Observation Report

September 24, 2019

Re: Meadow Creek Condominiums, Vail, CO
(Building J)
Project No. 0307-19 J

(Image A, Unit 1 & 2)

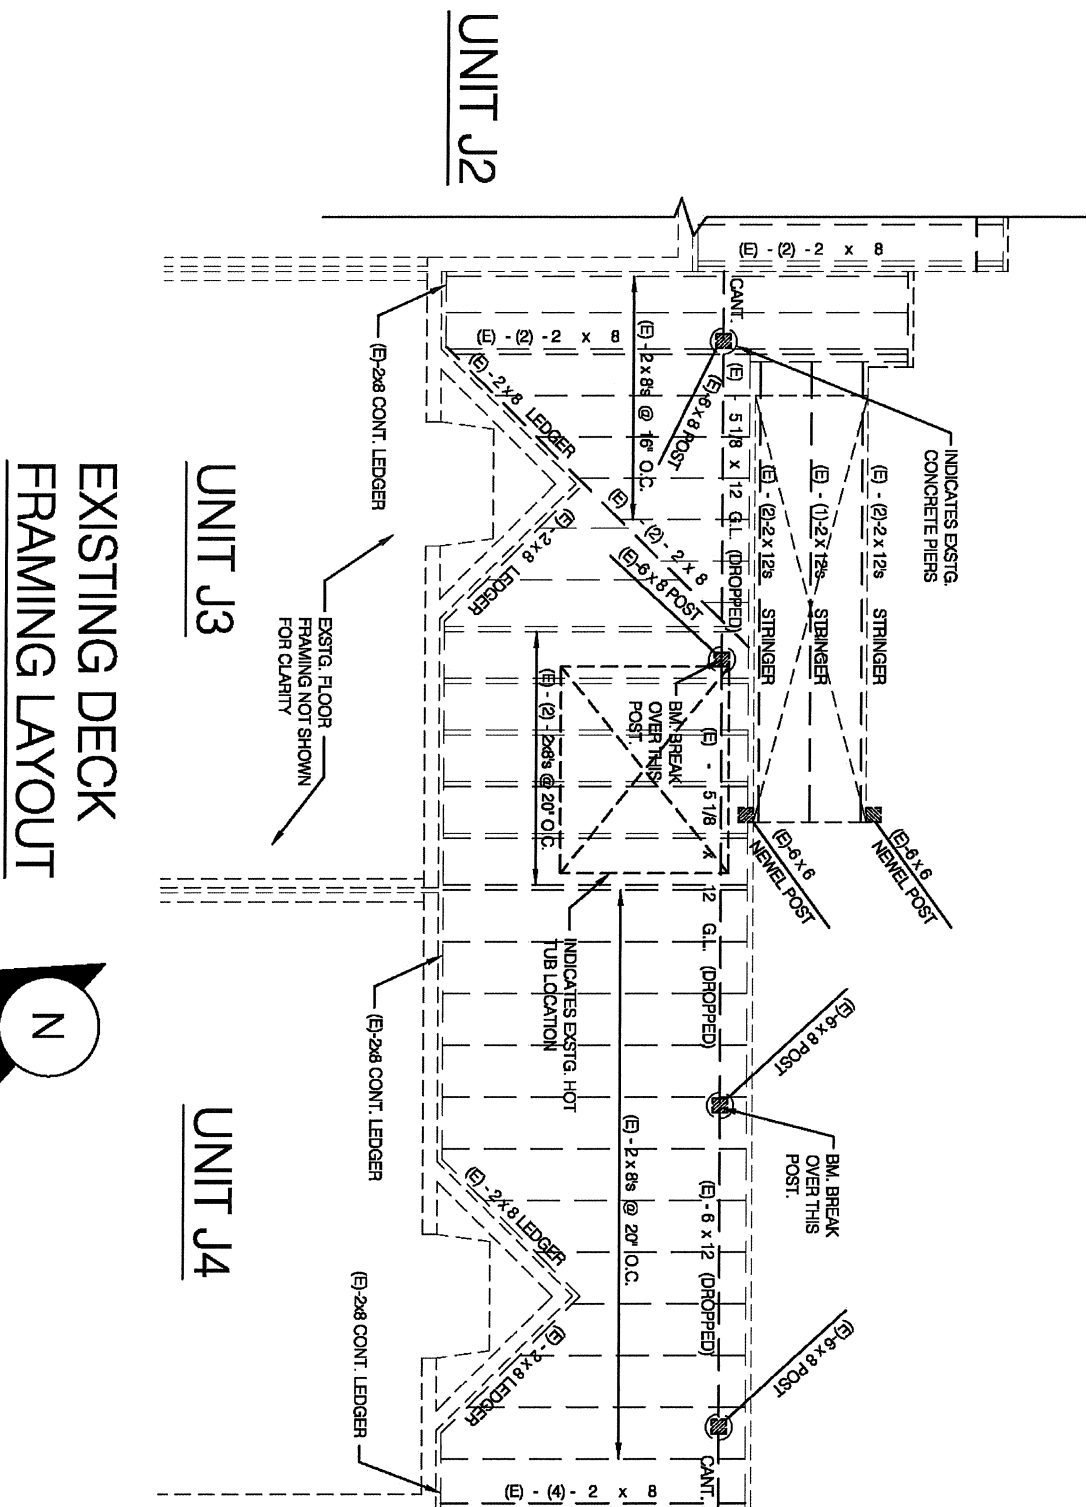
Building J consists of four units and staggers two units at a time from the northeast towards the southwest approximately 8 feet starting with units J1 and J2. The exterior decks are located on the east side of the building and are approximately 10 feet above the finished grade. They extend approximately 10 feet from the building and the lengths of the decks vary from unit to unit. There is a framed partition wall that divides the decks in half. This partition wall appears to be located between the two units at the party wall. The decks are accessed by an exterior door located on the east side of each individual unit and an exterior set of stairs for Unit J3. The exterior decks appear to be framed with 2x wood decking on a combination of 2x8 dimensional lumber joists, timber or glulam beams and posts. (See Image A, B and attached layouts)

(Image J)

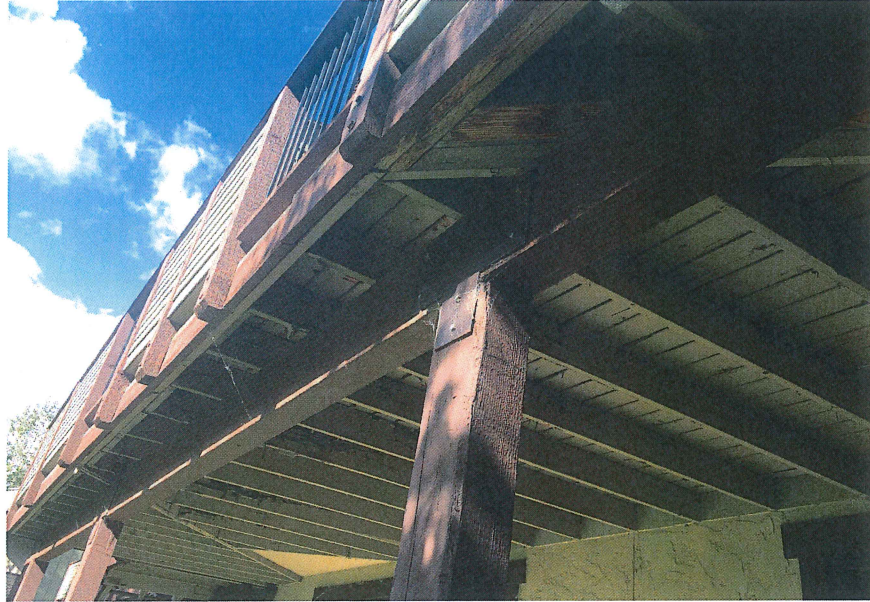
Unit J1: A section of this deck appears to have been remodeled at some point in time. The deck is connected to unit J2 and is separated in the middle by a framed partition wall. A section of this deck located to the north of the cantilevered floor above appears newer than the remainder of the deck. This deck also has a hot tub on it that is approximately 6'-0" x 6'-0" in size. (See layout for location) The newer section appears to be framed with (2)-2x8 deck joists spaced at 16" on center with 2x6 decking. One of the (2)-2x8 deck joists appears to be treated and the other does not. Most of the joists bear on mechanical steel hangers on the west end and cantilever approximately 12" on the east. The west end hangers are nailed to 5x8 that appears to be screwed to a 4x8 ledger that is on an approximate 45 degree angle to the deck joists. (See Image C and Attached Layout) The cantilevered ends of the joists bear on a dropped 6x12 beam. The beam spans continuously over three separate posts that are spaced out approximately 3'-8" and 9'-0" and cantilevers to the north approximately 6". The two posts to the north are 6x6's and the post to the south is a 6x8. At the top of the 6x6 posts, there appears to be a steel vertical plate to the outside that is lagged to the post and dropped timber beam. There also appears to be a steel mechanical cap located on the insides of the posts. (See Image D) Both of the 6x6 posts bear on concrete circular piers and appear to have a mechanical steel base plate. At the top of the 6x8 post located to the south, there appears to be a custom steel T-shaped cap. (See Image E) This post also supports a 5 1/8" x 12" glulam beam that also supports some of the deck for unit J2. The 6x8 post bears on concrete circular pier and does not appear to have a mechanical steel base plate. The remainder of the deck for unit J1 appears to be framed with 2x8 deck joists spaced at 20" on center with 2x6 decking. Some of the paint that was applied to the underside of this decking and joists has peeled away. Most of the joists bear on mechanical steel hangers or are toe-nailed on the west end and cantilever approximately 12" on the east. The west end hangers are nailed to either a 2x8 ledger that is perpendicular with the deck joists or toe-nailed to a 2x8 ledger that is on an approximate 45 degree angle to the deck joists. The ledgers appear to be nailed to the side of the building. The cantilevered ends of the joists bear on a dropped 5 1/8 x 12 glulam beam that supports some of the deck for unit J2. Some of the nails appear to be weathered and show signs of rust. Some of the deck joists are cracking and appear to be rotting on the top in areas and they also appear to be taking on a blackish/gray weathered look. (See Image F) The 5 1/8 x 12 glulam beam spans continuously over two separate 6x8 posts that are spaced apart approximately 14'-2". The 6x8 post to the north supports both the timber and glulam beams described above. The 6x8 post to the south supports two separate glulam beams that is described in unit J2 and appears to have a custom steel T-shaped cap located on the outside and does not appear to

have a base plate connection where it bears on a circular pier. (See Image J and attached layout)
